INVITATION TO BID 2026-01
CITY OF PARKER
2025 ROADWAY RESURFACING PROJECT

**ADDENDUM NO. 5
NOTICE TO BIDDERS**

Issued September 30, 2026

SCHOOL TURN LANE PAVEMENT DETAIL
N.T.S.

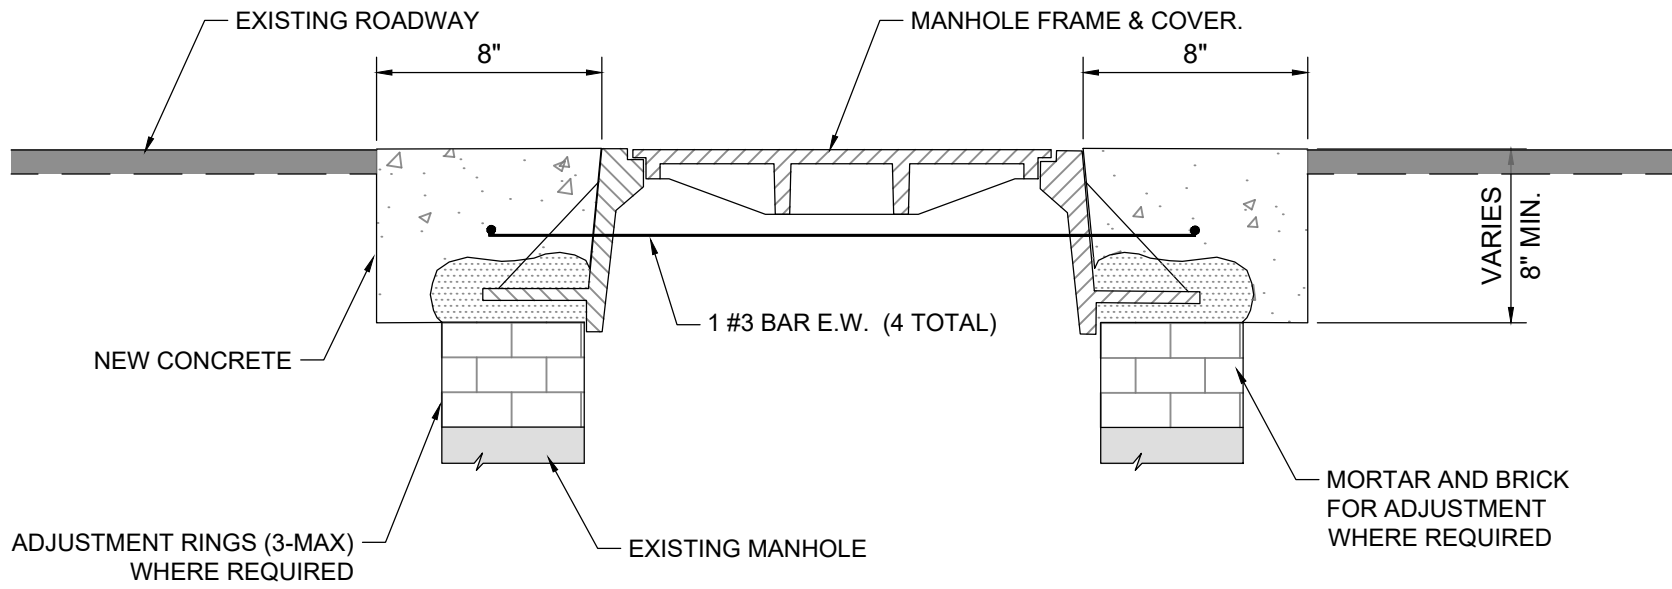
- c. Sheet C4.0 – Construction Details and Sections: Note has been **ADDED** to the School Turn Lane Pavement Detail which states, **“PROPOSED CONTRACTOR SHALL GRADE EXISTING GROUND AND PREPARE FOR ASPHALT INSTALLATION TO ENSURE SMOOTH GRADED FINISH.”**
